DEVELOPMENT REVIEW BOARD
SUPPLEMENTAL SUBMITTAL

PROJECT NO. PR-2020-004747

Application No. SI-2021-00484

RESPONSES TO CITY COMMENTS

BUILDING MOUNTED SIGNAGE

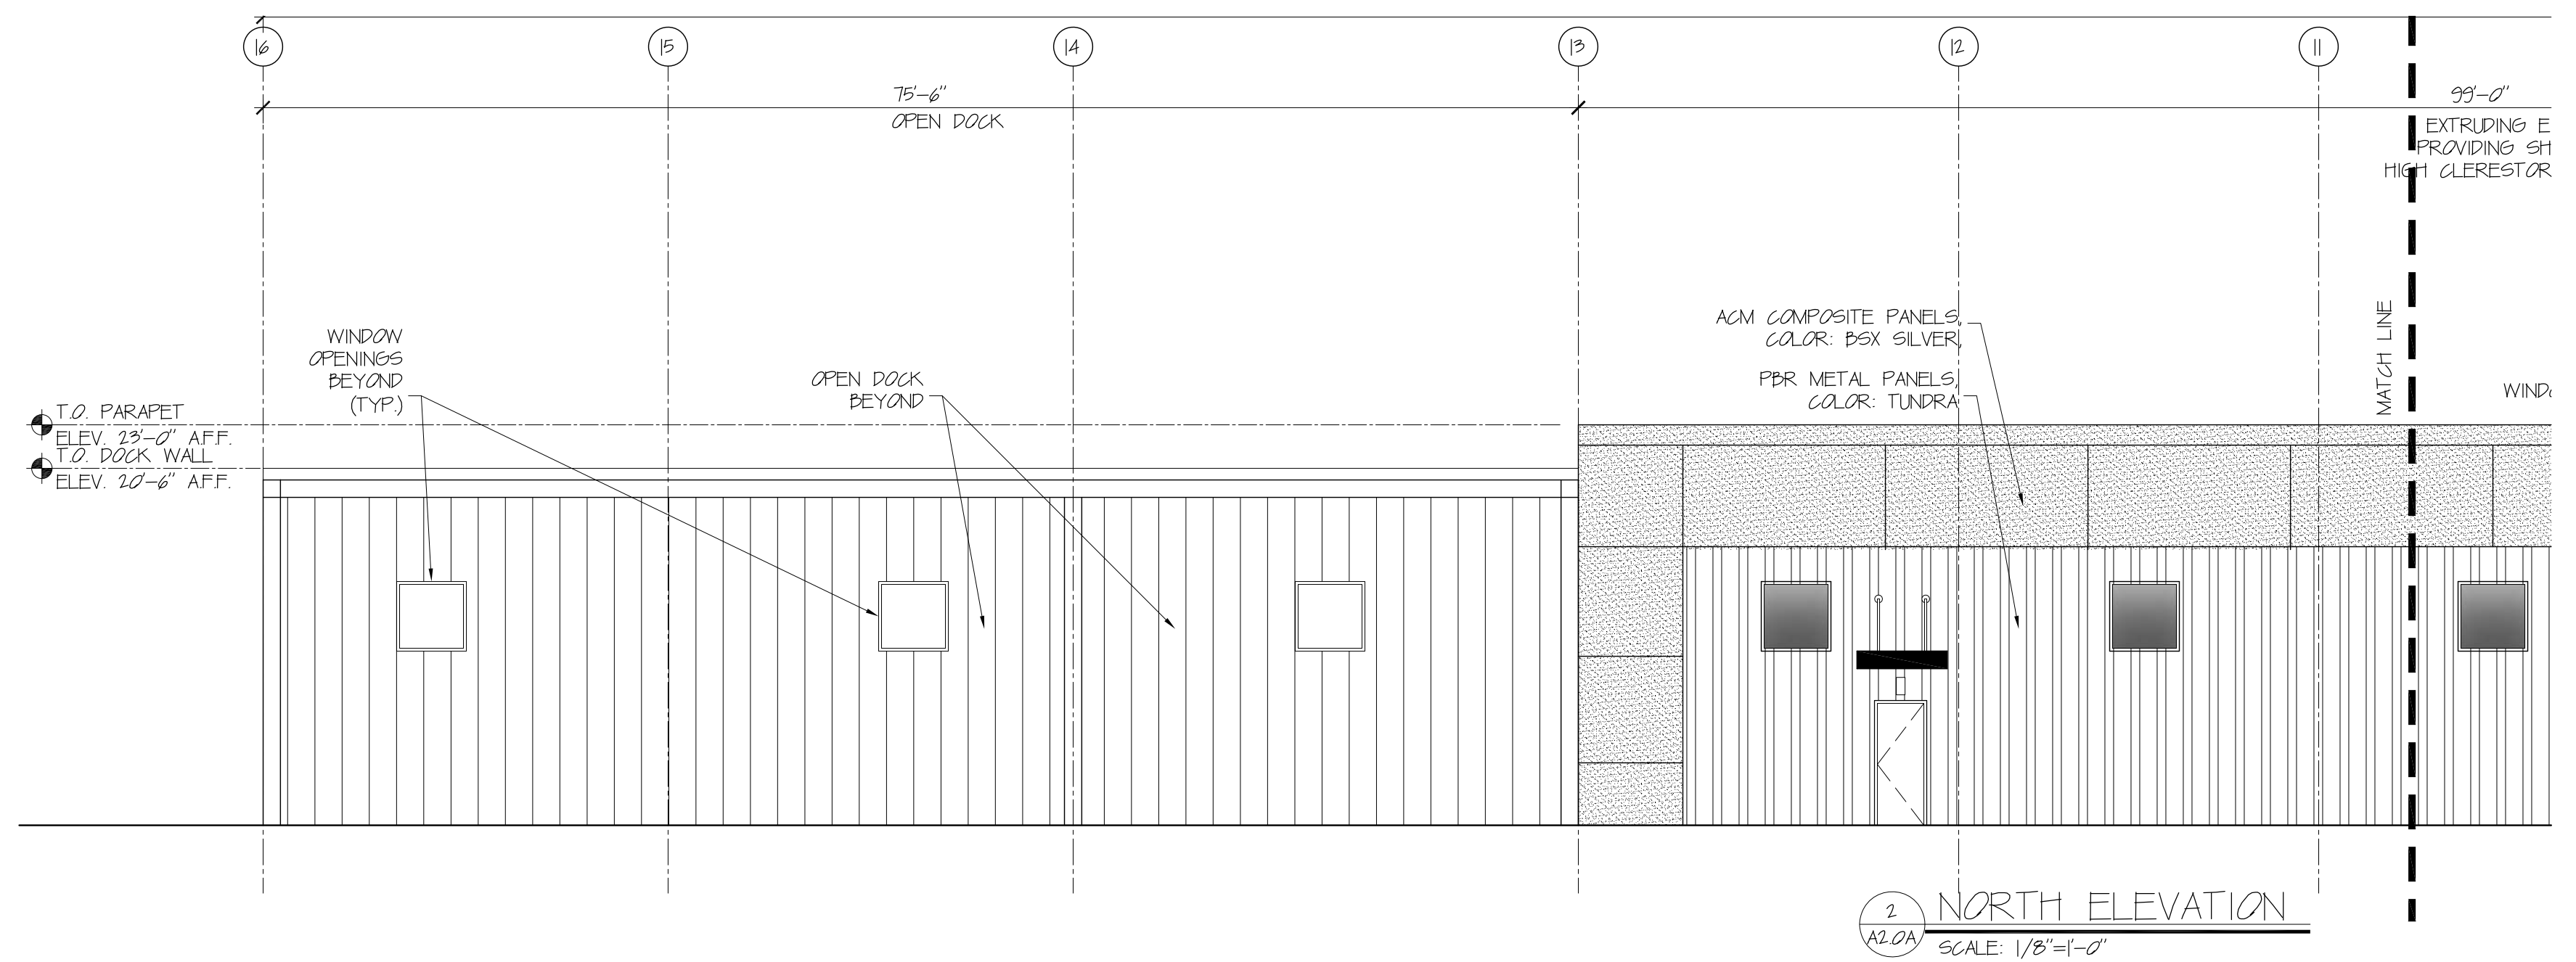
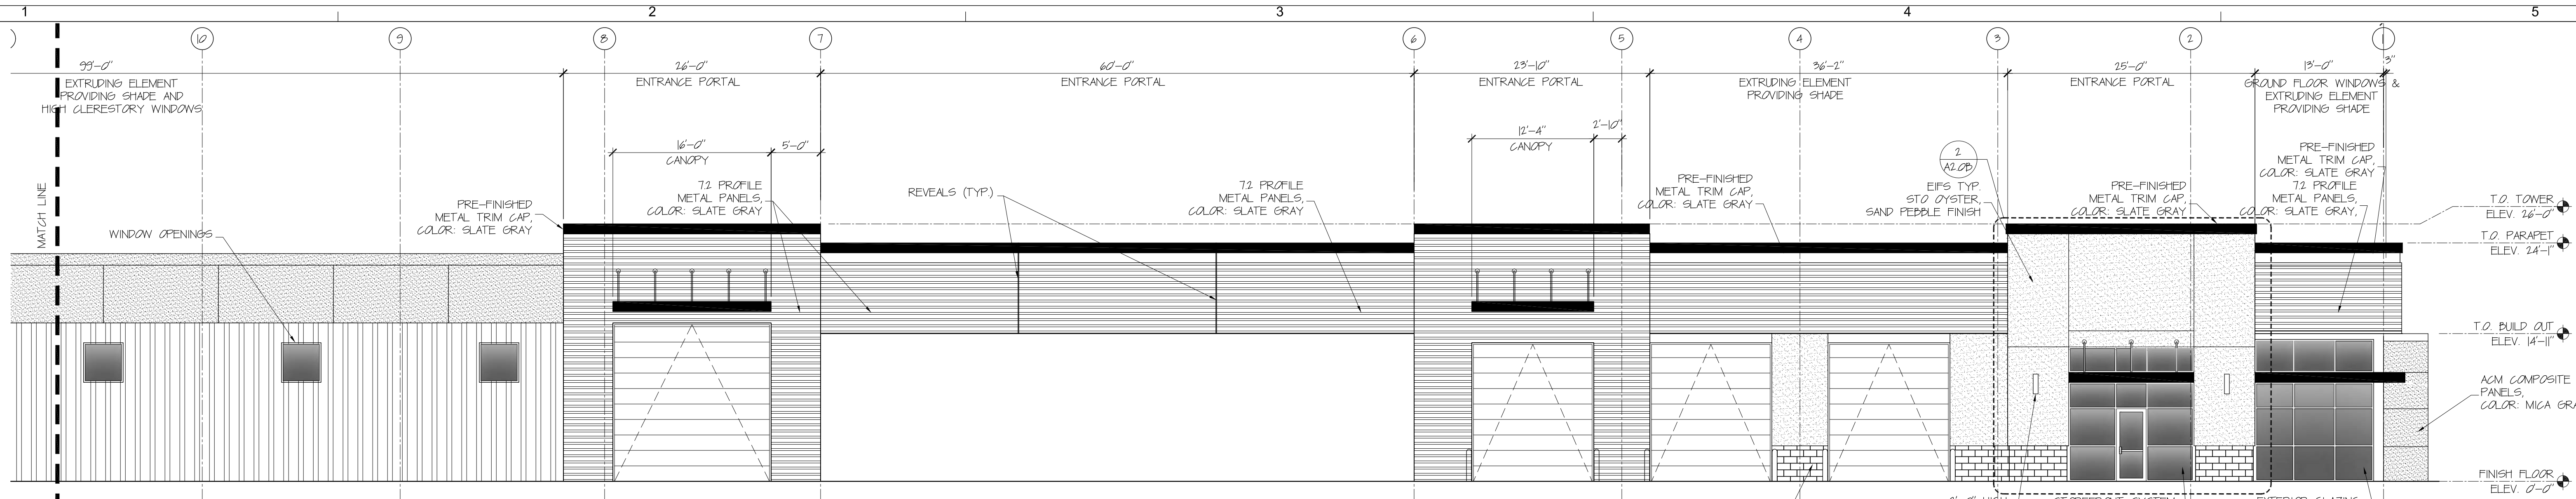
Elevation Review Comments:

The elevation needs to meet the following requirements:

1. Façades shall be designed to provide a sense of human scale at ground level by providing a clear architectural distinction between ground floor levels and all additional levels.

2. Each street-facing façade shall incorporate at least 2 of the following features along at least 30 percent of the length of the façade, distributed along the façade so that at least 1 of the incorporated features occurs every 40 feet.

3. Each street facing façade longer than 100 feet shall incorporate at least 1 of the following additional features.

- a. Wall plane projections or recesses of at least 1 foot in depth at least every 100 feet of façade length and extending for at least 25 percent of the length of the façade.
- b. A change in color, texture, or material at least every 50 feet of façade length and extending at least 20 percent of the length of the façade.
- c. An offset, reveal, pilaster, or projecting element no less than 2 feet in width, projecting from the façade by at least 6 inches, and repeating at minimum intervals of 30 feet of façade length.
- d. Three-dimensional cornice or base treatments.
- e. A projecting gable, hip feature, or change in parapet height at least every 100 feet of façade length.
- f. Art such as murals or sculpture that is privately-owned or coordinated through the City Public Arts Program

The North façade:

incorporates ground floor windows, primary entrance, high clerestory windows, portals, canopies and extruded wall elements providing shade. The total length of the façade is 358 feet and 9 inches. 30 Percent of the façade is 108 feet.

2a) Ground floor transparent windows occur along a total of 24 feet along the façade between column lines 1 and 3. Windows begin at floor level.

2b) Building has only one level, however high clerestory windows were placed 10 feet high between columns 8 and 13.

2c) Primary pedestrian entrance between columns 2 and 3.

2d) Entrance portals, canopies and extruding elements providing shade have been placed along a total of 310 feet along the façade length. See elevation. Arcades, trellises and awnings not provided.

The entrance portals, ground floor windows, high windows, primary pedestrian entrance, entrance portals, canopies and extruding elements occur along more than 30 percent of the building at least every 40 feet along the façade.

The South façade:

incorporates extruding elements, an entrance portal and high clerestory windows. The total length of the façade is 358 feet and 9 inches. 30 Percent of the façade is 108 feet.

2d) Entrance portals, canopies and extruding elements providing shade have been placed along a total of 310 feet along length of façade.

The entrance portals, high clerestory windows, entrance portals, canopies and extruding elements providing shade occur along more than 30 percent of the building at least every 40 feet along the façade.

The North façade:

3a) Wall plane projections or recesses of at least 1 foot in depth at least every 100 feet of façade length provided.

3d) Three dimensional cornice provided

3e) Change in parapet height every 100 feet of façade length provided.

See North elevation for change in parapet height every 100 feet.

The South façade:

3e) Change in parapet height every 100 feet of façade length provided.

See South elevations for change in parapet height every 100 feet.

At least 1 of the required elements has been incorporated along the north and south façades.
